Unreviewed Safety Question Evaluation Form

Unreviewed Safety Question Evaluation # 96-0027 Rev. No. 0 Page      of     Originating Document: DCP No. 95-11258-6/UFSAR CN#2026 Rev. No. 0

DCP 95-11258-6 proposes to replace damaged original compression nuts in the Incore Neutron Flux Monitoring System Bottom Mounted Instrument (BMI) thimble guide tubes with an alternate split nut design. During 1RE06 several of the compression nuts were found galled and could not be repaired.

PROVIDE OPTION OF USING A SPLIT NUT DESIGN FOR THE HIGH PRESSURE FITTING FOR THE BMI FLUX THIMBLE

FIGURE 1  
ORIGINAL DESIGN

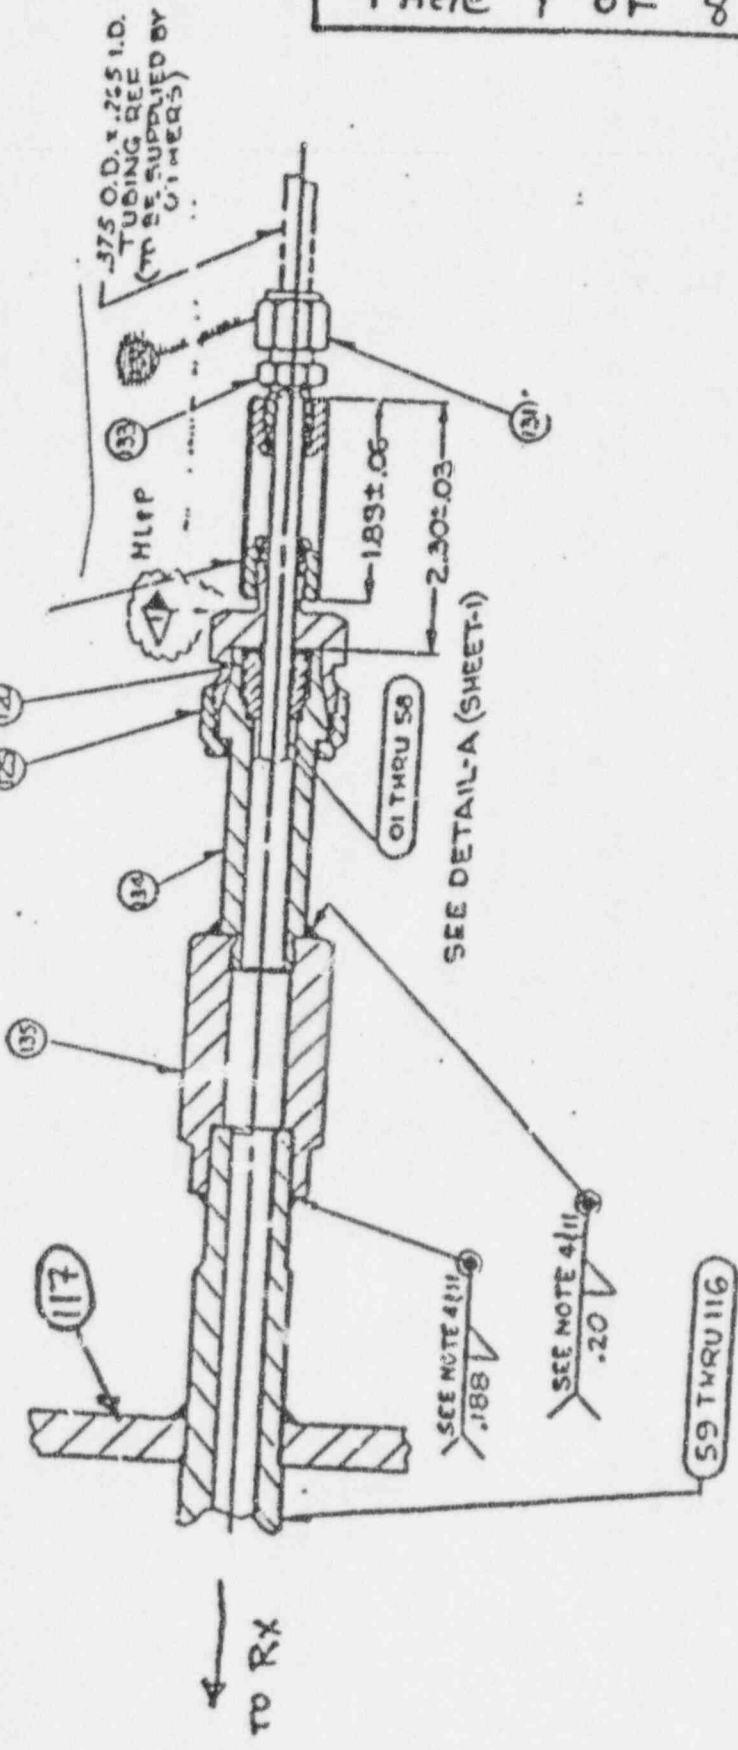
The split nut design performs the same function as the original compression nut. Instead of being made as a single cylindrical compression nut (Ref. Figure 1), the alternate nut design consists of two half cylindrical pieces fastened together by two allen head bolts (Ref. Figure 2). This design allows the compression function to be performed without the disassembly of the thimble tube for installation.

The BMI Thimble Guide Tubing consists of heavy walled tubes extending from the seal table to the socket welds at the RPV bottom head penetrations. Fifty-eight Guide Tube are provided in the bottom of the reactor vessel. Each tube is a series of 3 shorter sections joined with socket welds at 2 couplings. The pressure boundary is maintained at the seal table by compression type fittings. (see Figure. 1)

# FIGURE 2

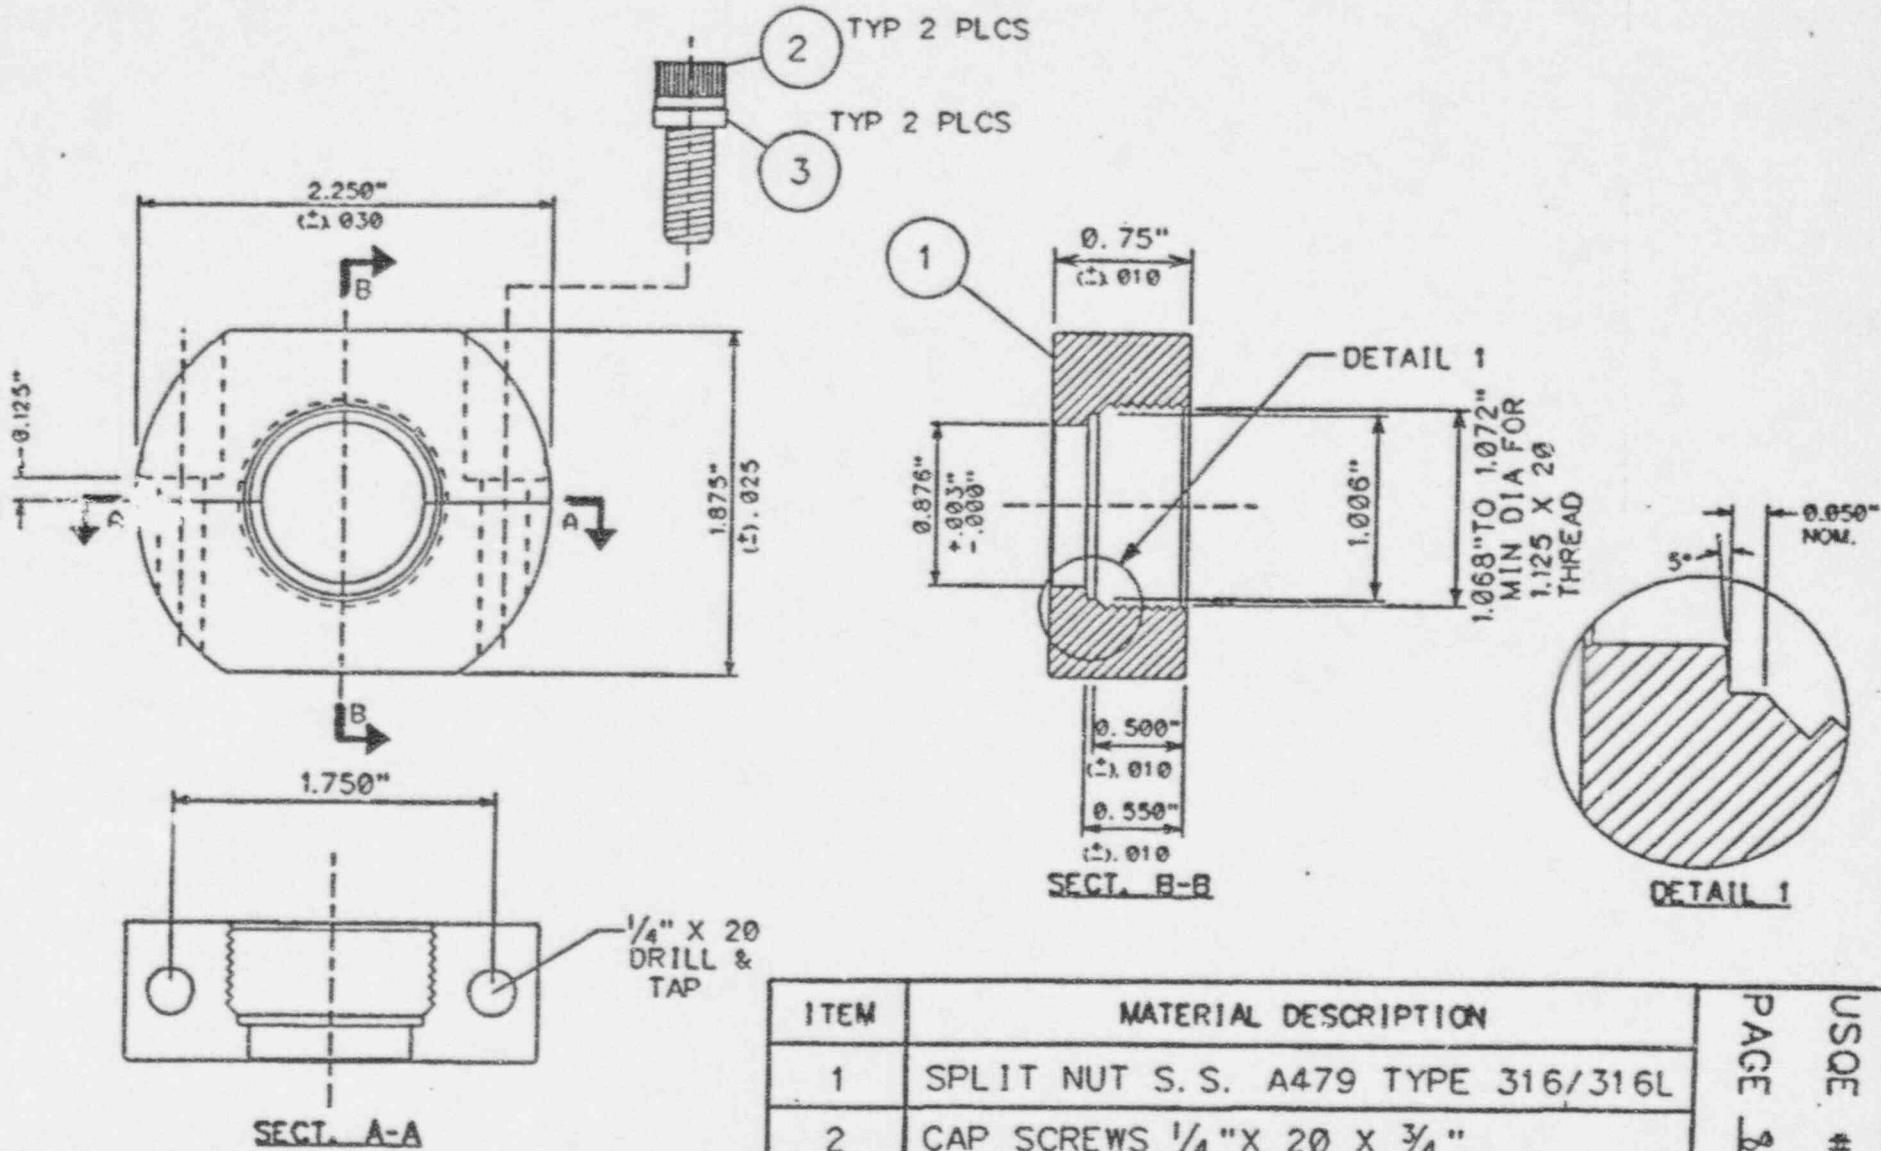
A review of the stress report for the incore flux monitor thimble tubes shows that the seismic response from the original analysis is still bounding. An analysis of the additional weight from the alternate design split nut effect on the tubing was performed. The results show that an additional split nut weight of approximately 70 pounds is required to affect the seismic response to unacceptable levels, and the actual split nut weighs much less (Ref. Calc 0090-1-00014WN, Appendix A; DCN 96-03713).

The alternate split nut design is bounded by the ultimate bursting pressure of the tubing. The vendor performed a destructive pressure test on the tubing material to a pressure of 16,600 psig. The HL&P analysis shows that the split nut design can withstand the internal water pressure load of 16,600 psig. (This is based on actual tested yield strength of 52 ksi. At F837 Minimum yield of 26 ksi, first yield would occur at 9000 psi, which still provides a large margin compared to system design pressure.) Since the maximum design pressure of the Reactor Coolant System is 2485 psig, adequate margin exists. (Ref. Calc. 0090-1-00014WN, Appendix A; DCN 96-03713).

The replacement material for the split nut is ASTM A479 type 316,316L which was purchased under P.O. QS0004758. This item was supplied as Safety-Related Quality Class 4 Material with a CMTR. The fastener material is ASTM F837 condition CW which was purchased under P.O. RS-9360. This item was supplied as Safety-Related Quality Class 4 Material with a Certificate of Conformance. Site tensile tests of 3 cap screws from the lot of material had yield strengths above 45,000 psi and ultimate tensile strengths above 120,000 psi. The material strength of the caps screws and split nut assemblies has been demonstrated to be consistent with Code of Construction materials.

This arrangement was pressure tested at 5,000 psi with no leakage. This is two times the design pressure. DCN 96-03713 to the stress report (0090-1-00014WN, Appendix A) shows that the primary stress levels are consistent with the original design. Therefore, the requirements of ASME Section XI are satisfied.
